MACHINE SERVICE BULLETIN NO. 244

SUBJECT: LA 6-200-C Model

DATE: December 30, 1935

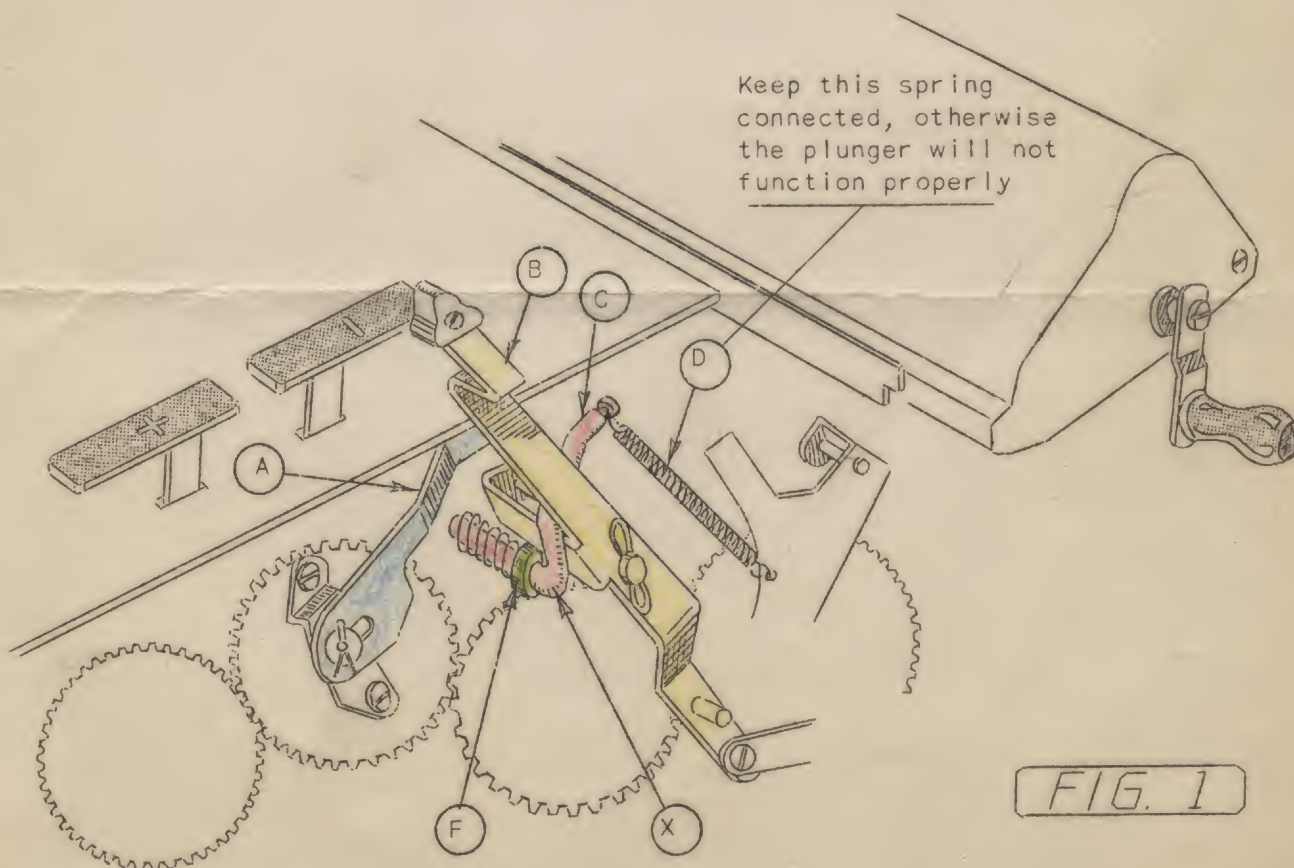
1. Stock has been removed from the 49070 counting finger (A) to avoid interference with the movement of the 47900 plunger rod. Figure 1
2. If, after the trip lever (K) and the 41-776 guide bracket (Z) have been adjusted the plunger rod (J) should strike the inner side of the 41-777x1 trip lever (K) instead of positioning over it as shown in Figure 3, remove stock from the top of lug (L) to suit,

FIG. 2

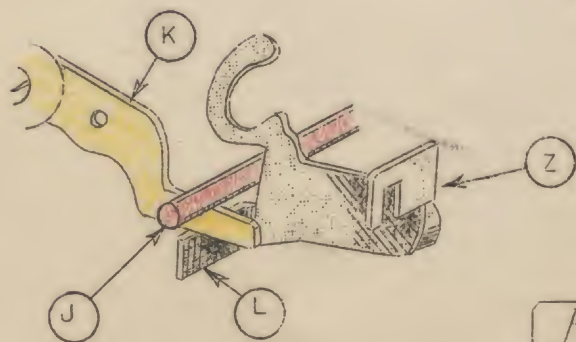
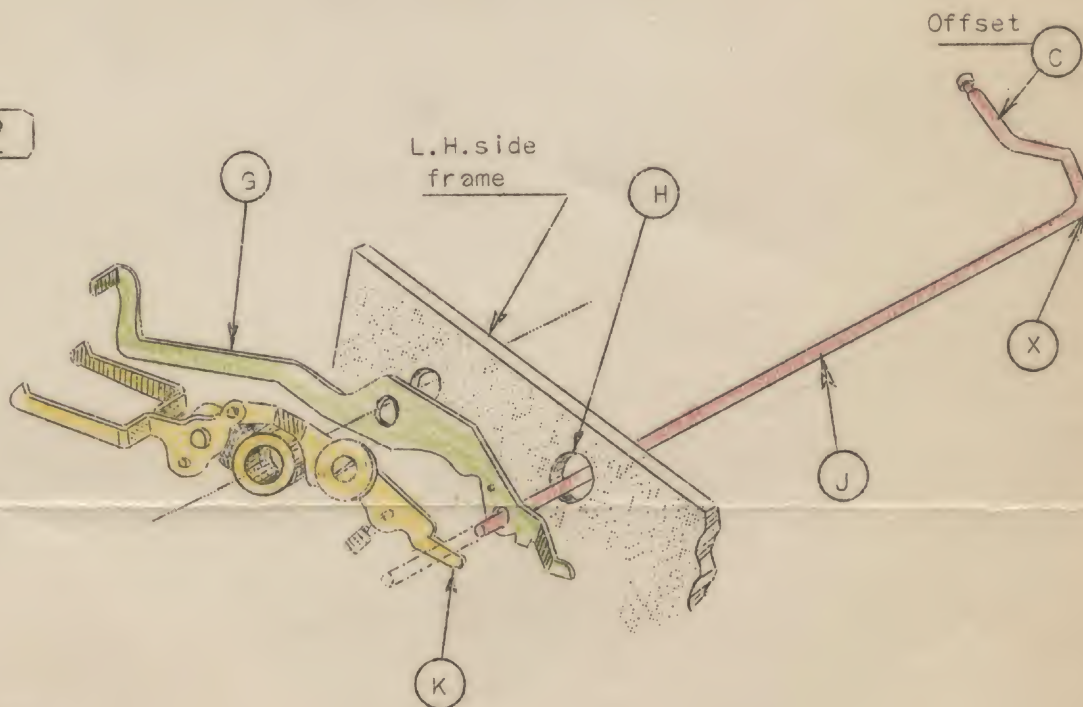
3. If the plunger rod (J) does not withdraw from engagement with the trip lever (K) when the multiplication lever is positioned toward the rear of the machine, bend the offset (C) of the plunger rod inward at (X).

4. If the plunger rod (J) does not engage the trip lever (K) when the multiplication lever is in neutral, bend the offset (C) of the plunger (J) outward at (X).

FIG. 3

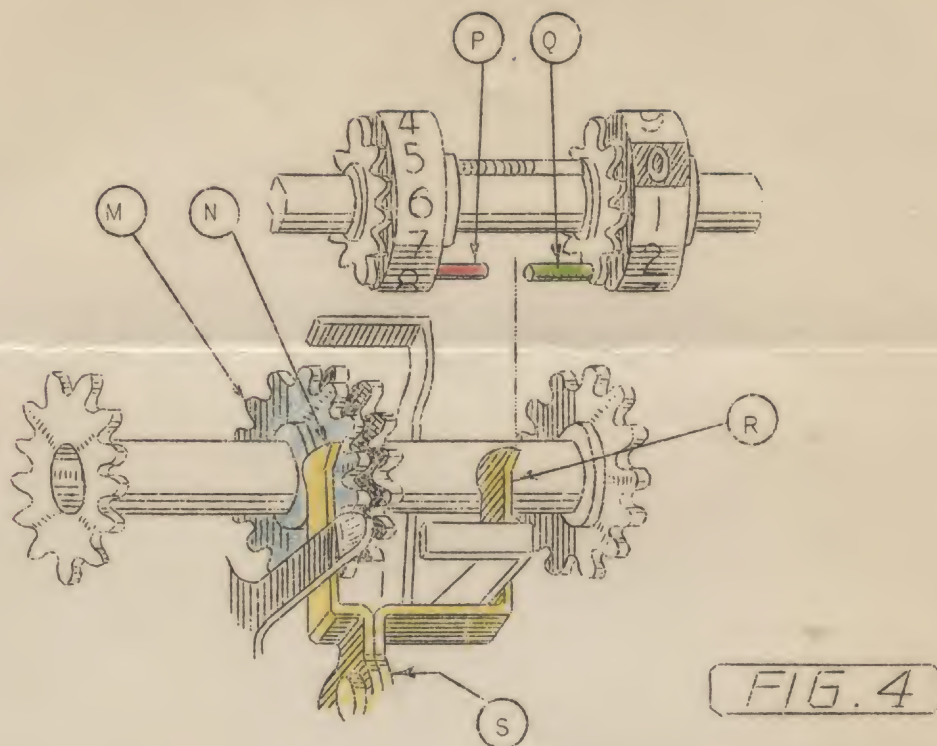
6. The outer prong (N) of the trip lever (S) should be adjusted as close as possible to the extra carry gear (M) without causing it to bind.
7. Care should be taken that the clearing pins (P) and the 41-527 carrying pins (Q) do not interfere with lug (R).

PARTS AND ASSEMBLIES USED - LA 6-200-C MODEL

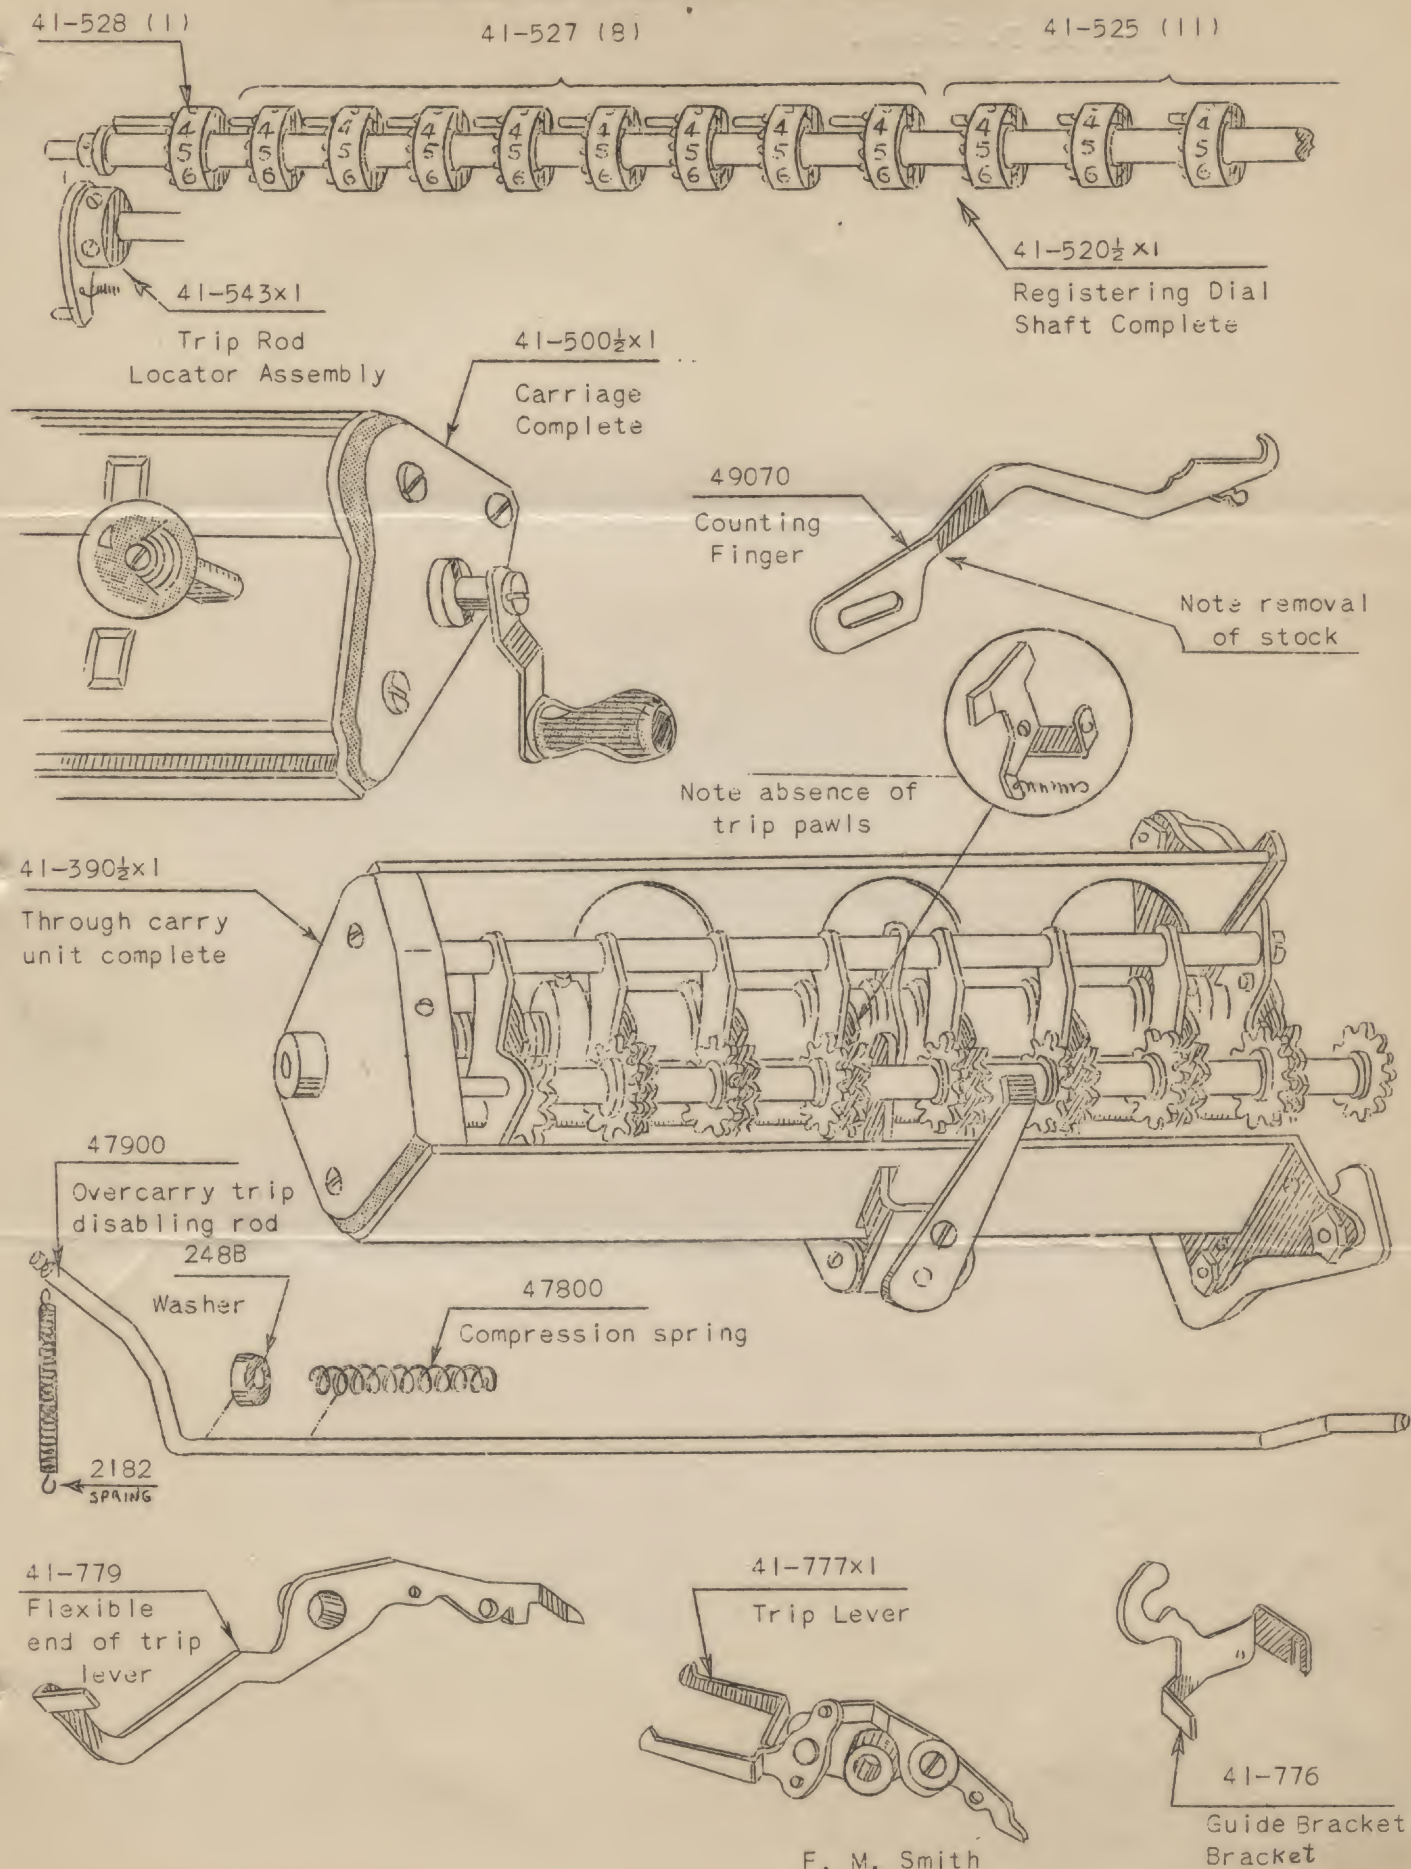
In addition to changes covered in Machine Service Bulletin No. 238, a change has also been made in the LA 6-200-C model whereby the machines will be equipped with a through-carry unit which does not contain trip levers 4310, trip lever shaft 4303½, overcarry trip lever 41-340½, screws 3007 or bearing 4309. Also a new trip lever 41-777x1 is used which is automatically disconnected during automatic multiplication by the use of a plunger rod. Long pins have been added to the 12th to 19th, inclusive, constant registering dial gears and a longer pin added to the last registering dial gear to compensate for the removal of the unit trip levers. A 47900 plunger engages the multiplication lever and extends through the side frames and the keyboard.

The left end of the plunger locates in a hole in a new style flexible end 41-779 which replaces the former 40-779, and also moves into engagement with the new 41-777x1 trip lever which replaces the 41-777. When the multiplication lever is returned to neutral, the trip lever is automatically coupled to the flexible end and serves as a regular trip lever when using the plus or minus bars or automatic division.
